Statistical Method Part A – Analysis of proposed options

[Draft]

Statistical Method Part A – Analysis of proposed Options

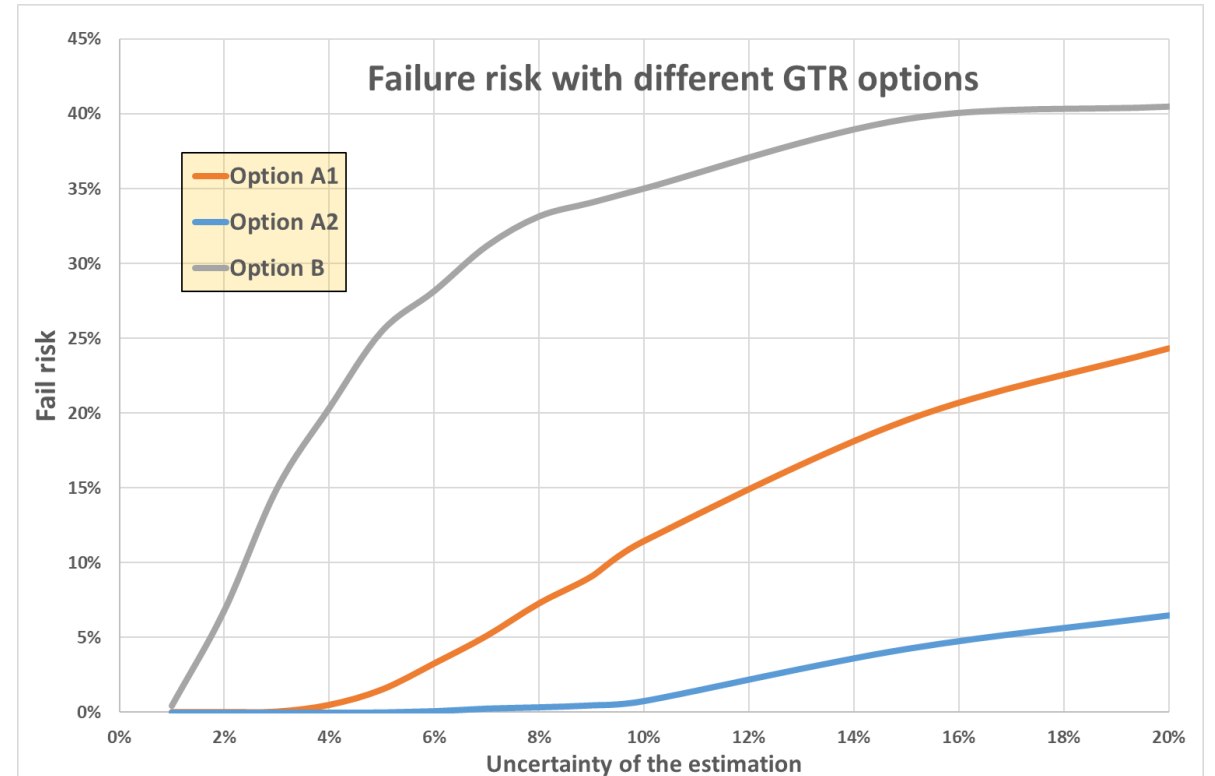
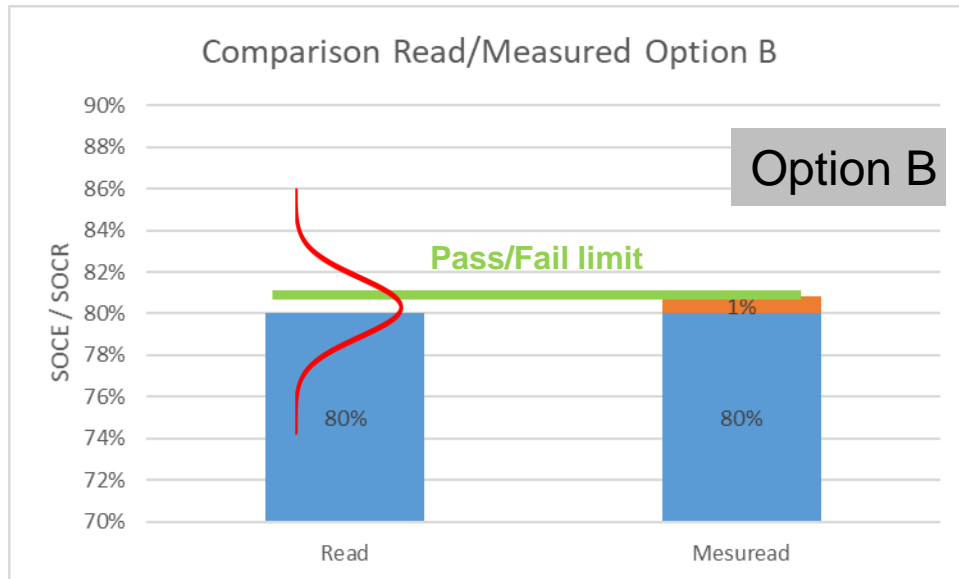
- Option B with ratio 1.05 is not working for the following example

- Option B with ration 1.05 and delta of 5% are requiring “unnecessary” additional measurements

- ➔ First example: At least 7 vehicles are required to get a pass (although first three vehicles are within the tolerances)
- ➔ Second example: At least 5 vehicles are required to get a pass (although first three vehicles are within the tolerances)

Conclusion: Option B as now is resulting in unnecessary additional costs, efforts in vehicle acquisition and test capacity. This additional efforts should be avoided as Part A vehicles are customer vehicles and as these add no additional value.

Reflections on Option A

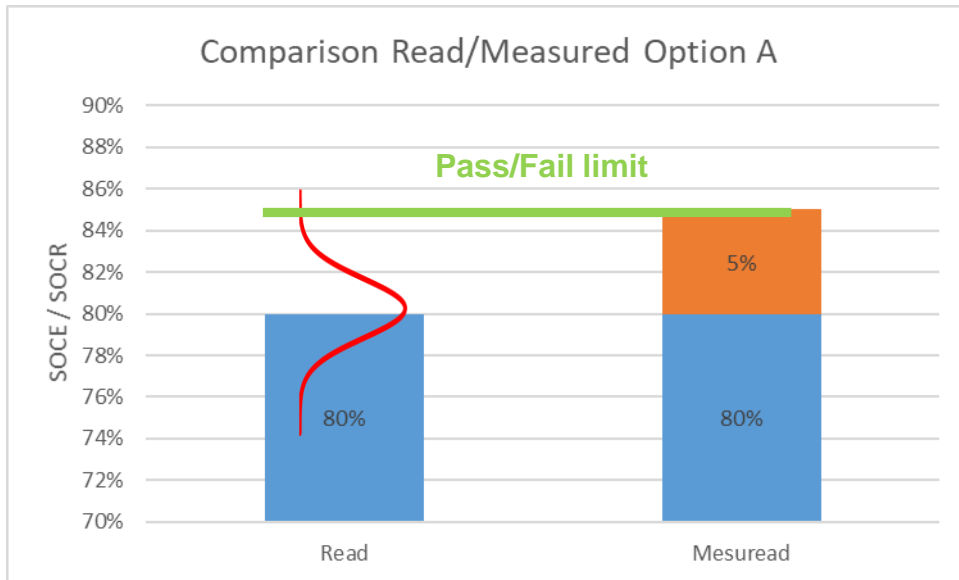
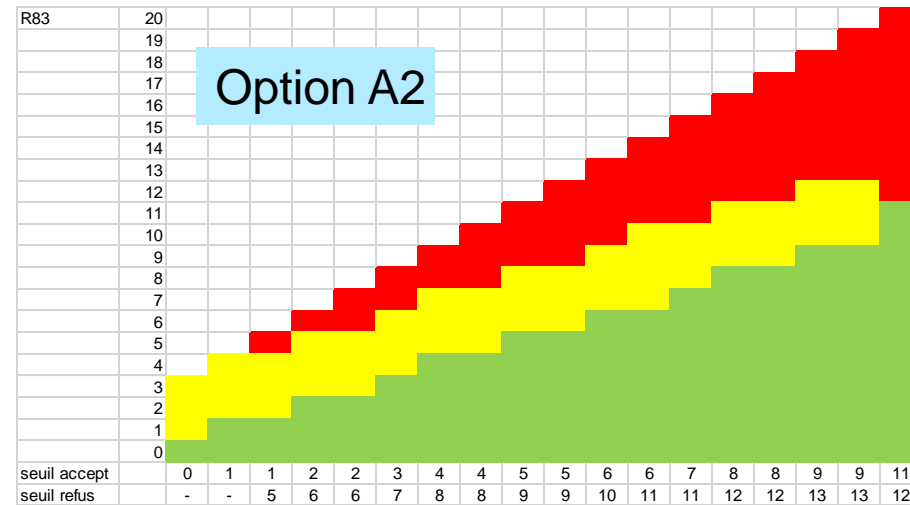
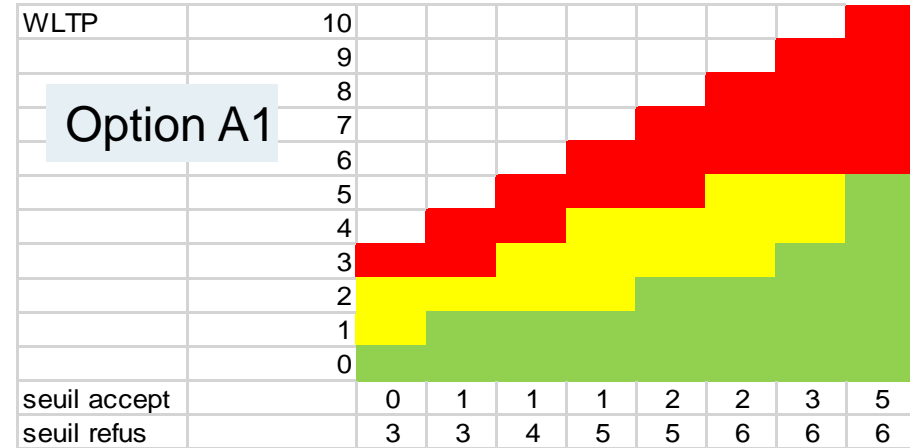
- Option B : SOCE/SOCR read are compared to SOCE/SOCR measured
- Due to the factor A [1.01] , the pass/fail limit is less than 1% over the measured value.
- With the uncertainty of the estimation, a non negligible part of the population is over the pass/fail limit

Making simulation with different uncertainties to calculate the risk of failure of a sample lot :

- the more stringent Option is B

- Option A : SOCE/SOCR read are compared to SOCE/SOCR measured + 5% points
- With the uncertainty of the estimation, a large part of the population is under the pass/fail limit

Opt B Decision Corridors for the Sample Mean (2 Standard Deviation used)

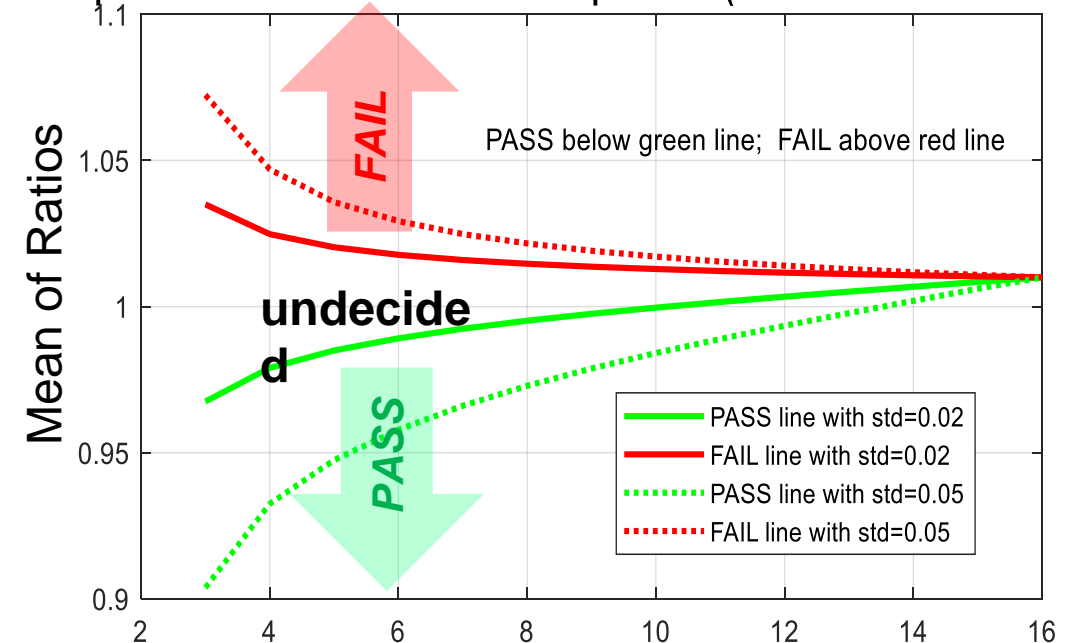
- Read / Measured ratio < 1 is required to get a high PASS rate for a monitor family.
- Mean and standard deviation for the read / measured ratios are the determining factors for this method.
